Final Quality Assurance Report for the INL Flood Hazard Study - Reducing Uncertainty for Paleohydrologic Bounds and 2-D Hydraulic Routing

Appendix A. Minutes from October Peer Review Meeting A-1
Appendix B. Quality Assurance of Topographic Data.....B-1
Appendix C. Peer Reviewer Comments and ResolutionsC-1

Figure 2-5 RO/AO layout for the 2000 project. Red diamonds are user points defined to compute analysis results. See Figure 2-1 for base map.

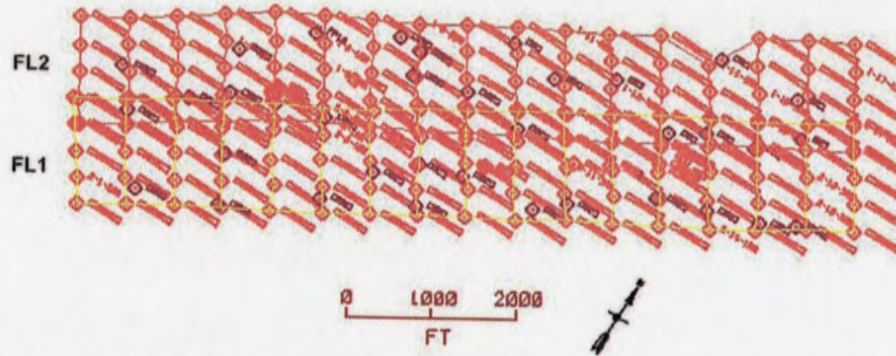
No.	Sec./Para. /Page No.	Comment	Resolution	Acc./Rej.
11	1.2/¶ 5/p 7	Line 1 – Chris Martin works for S.M. Stoller Corporation, not Stoller, Inc.	Changed per suggestion	*
12	2.1.1/¶ 1/p 8	Line 7 – Change "was" to "of" (...occupation time of 10 minutes...).	Changed per suggestion	*
13	2.1.1/¶ 1/p 8	Last line – Define "RMS" on first use.	Changed per suggestion	*
14	Figure 2-3	Y-axis label is cut off.	Changed per suggestion	
15	2.1.1/¶ 1/p 10	Last line – Is survey data in Appendix A of this appendix (Appendix A) or elsewhere in this report? Suggest that it be in "Attachment A" of this appendix.	Added "of this report" throughout to Appendix references. Retained use of Appendix since this portion is an independent report which also happens to be included as an appendix in the larger report.	*
16	2.1.2/¶ 1/p 11	Line 1 – See comment 15.	Ibid.	*
17	2.1.2/bullet 3 & Figure 2-5	It is not clear from the text or figure caption what the marks on Figure 2-5 represent. Clarify in the text.	Added text in caption to explain.	*
